# BULLETIN # 23

**PROJECT:** Harrison Recreation & Community Center – PHASE 2  
Harrison, NY

**RE:** New Door and Wall Infill at Lower Level

Sheet Title  
**NEW WALL AND DOOR AT ELEVATOR**

**ASK-26**

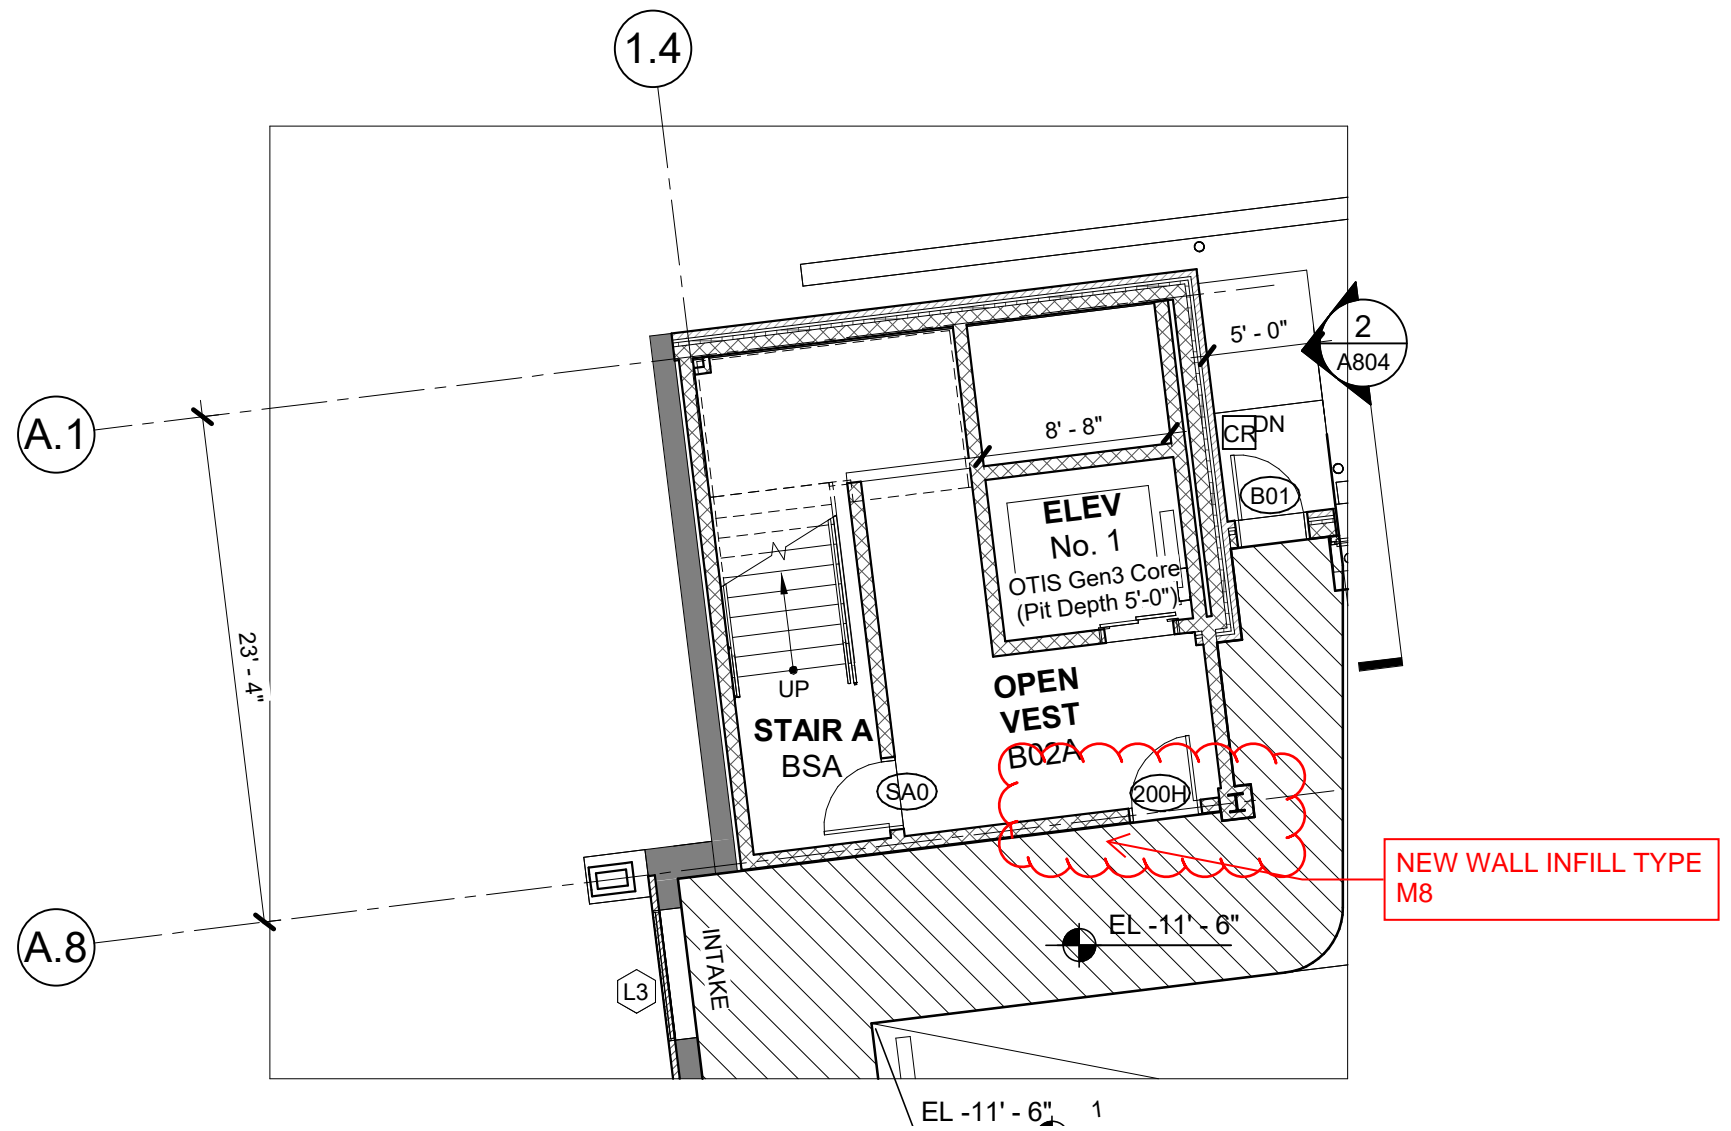
See attached ASK-26 for the new wall infill and door between the Parking Area and the Elevator Lobby. Infill wall type is M8 to match adjacent construction. New Door 200H per revised Door Schedule. Finishes to match Stair A. Relocate CUH shown on M203 from top of shaft to Vestibule B02A. Relocate Exit Sign to Garage side of door.
